Preliminary Drainage Report

The Shire at Old Ranch

PPR2410

February 27, 2024

DR-1  
 Drainage Plan

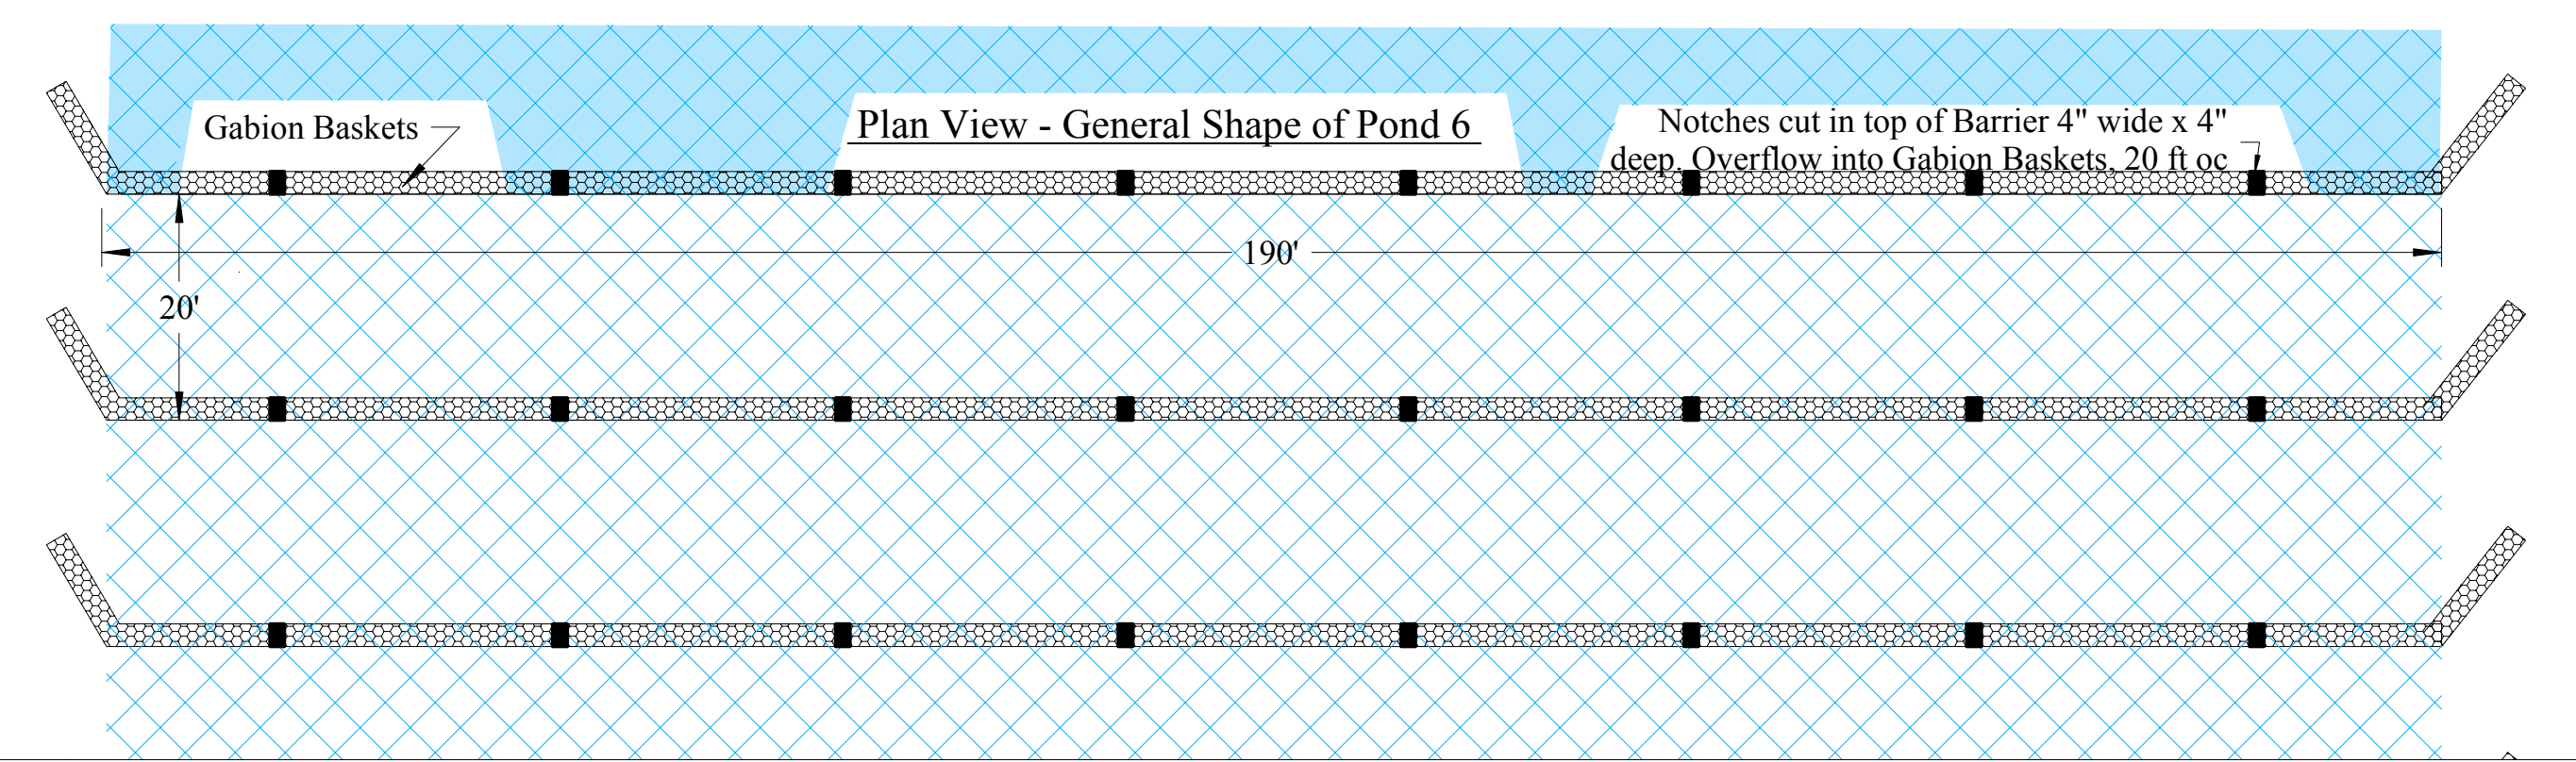
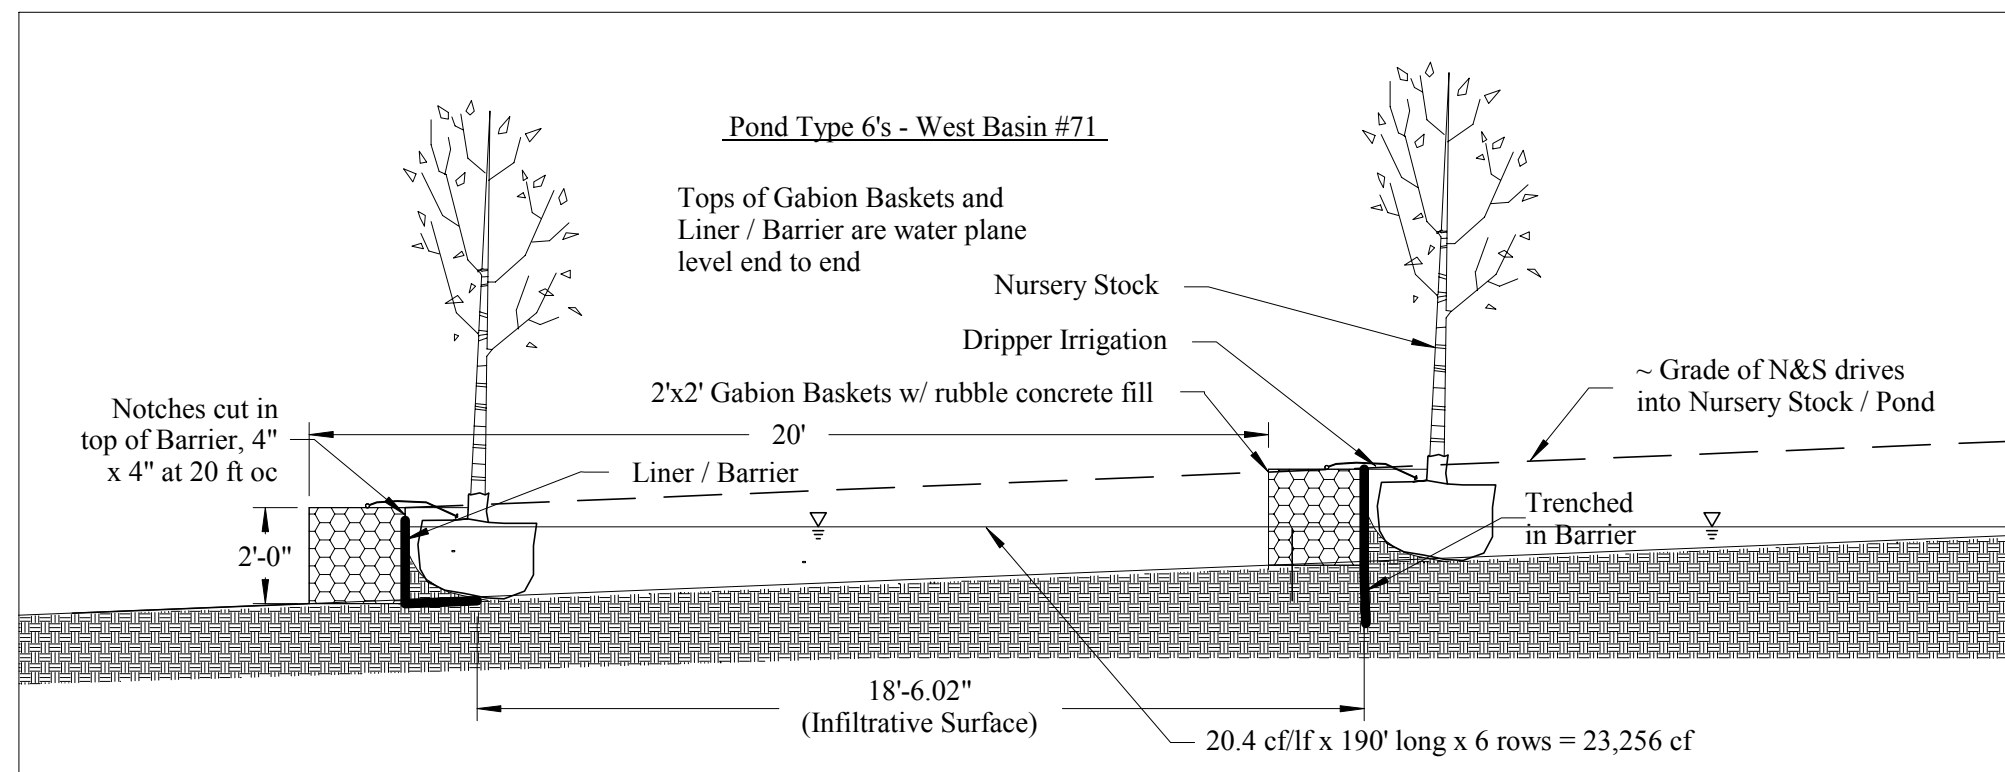
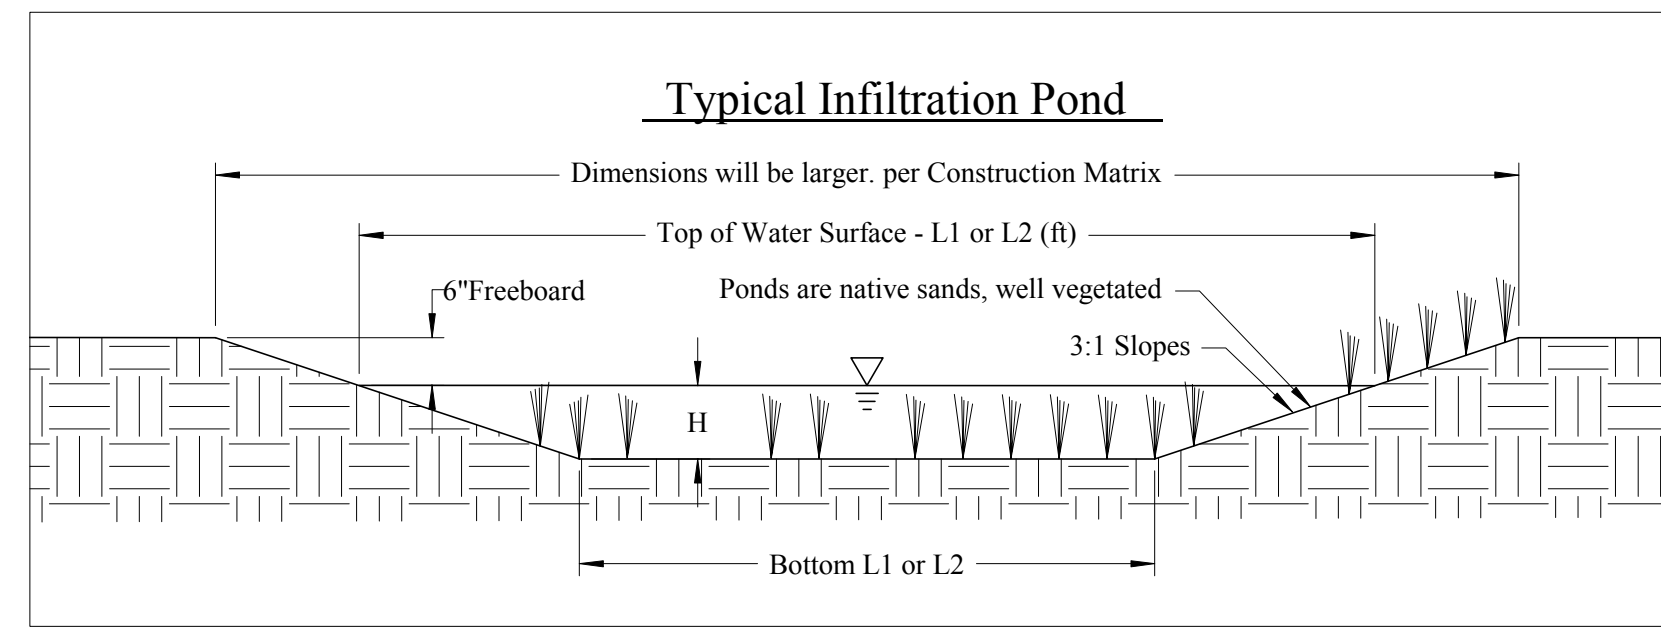
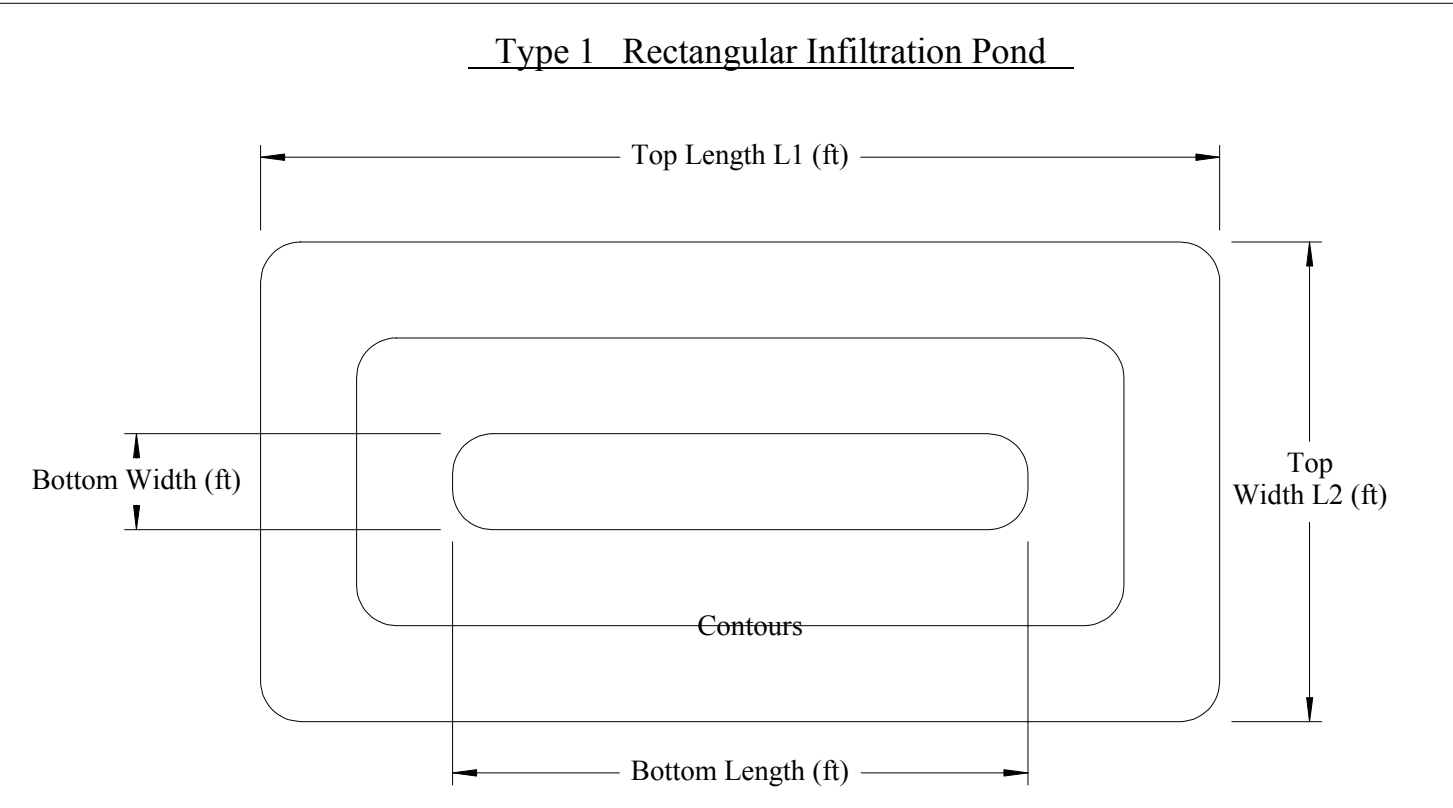
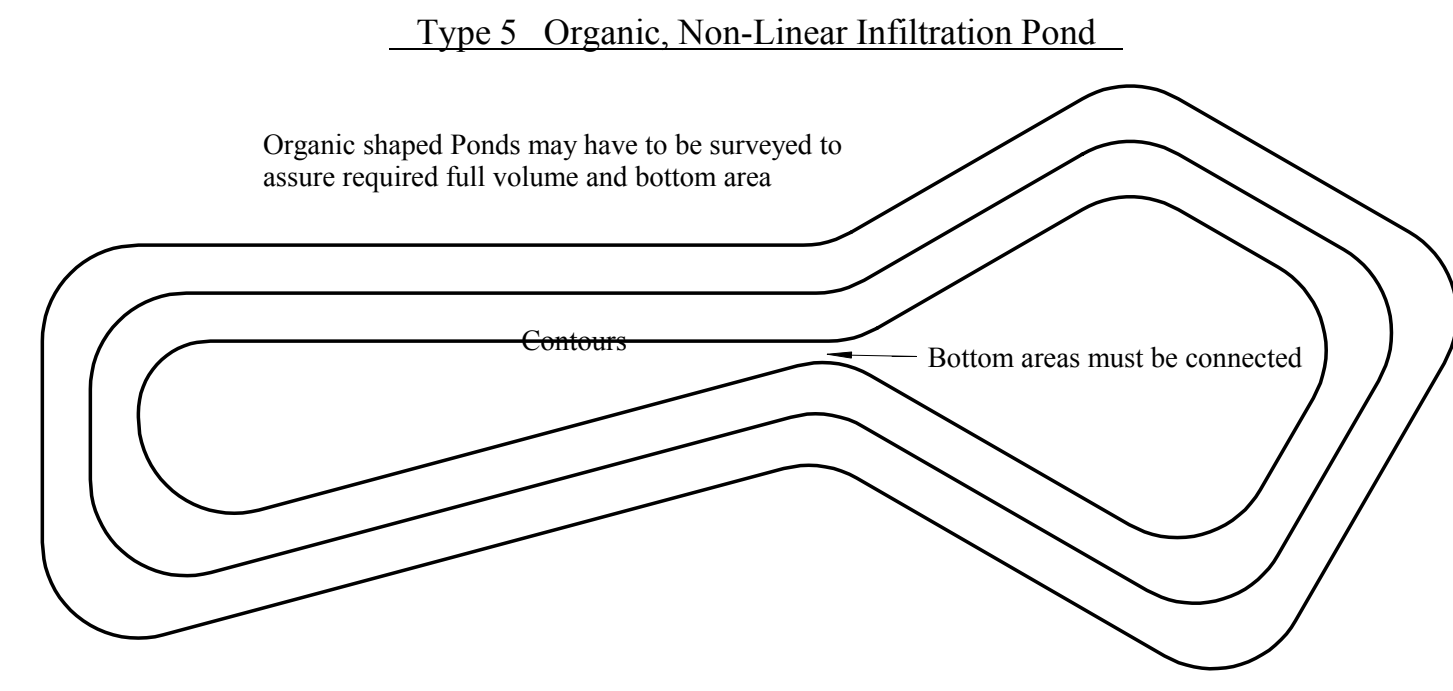
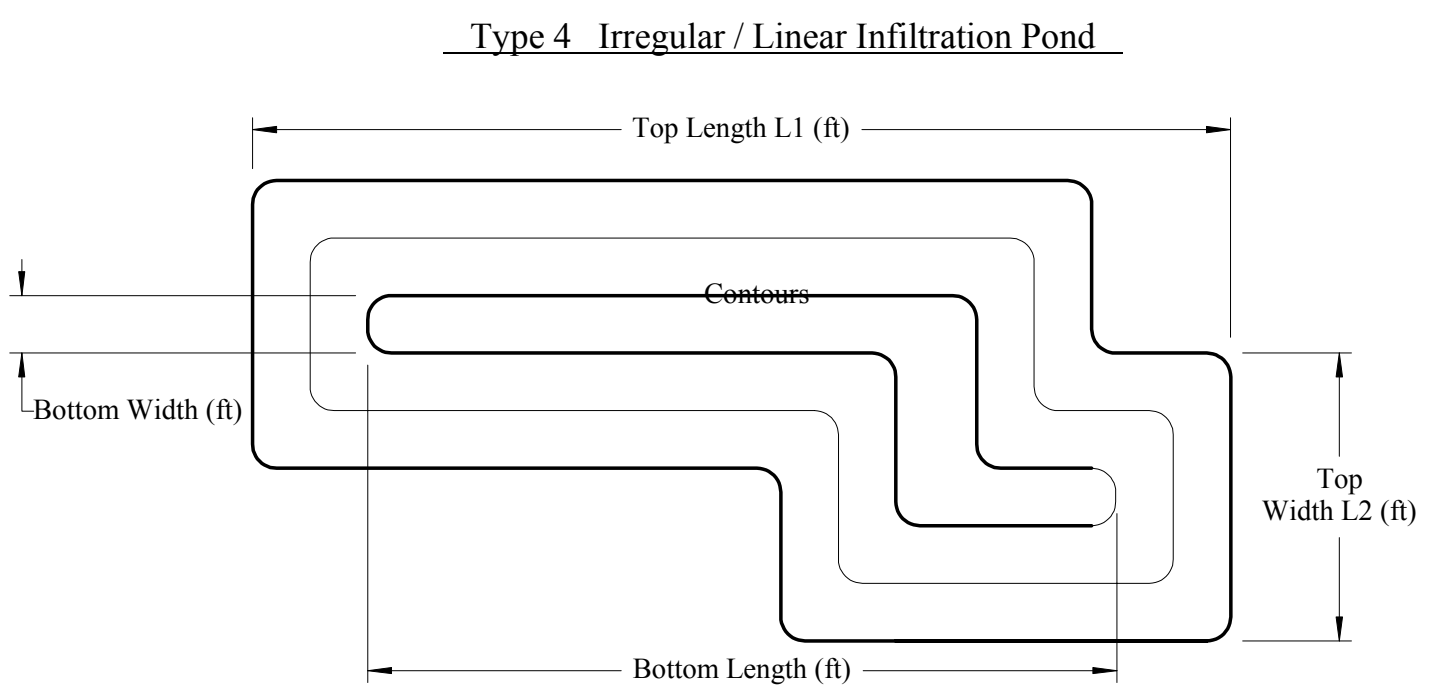
- Change label elevations of contour lines to be visible  
 - Label design points for basins  
 - Proposed contours around ponds?  
 - Identify any drainage structures under adjacent roadways  
 - Include driveway culvert at entrance to project site

provide a summary table with design points and basin flows for the minor and major storm.
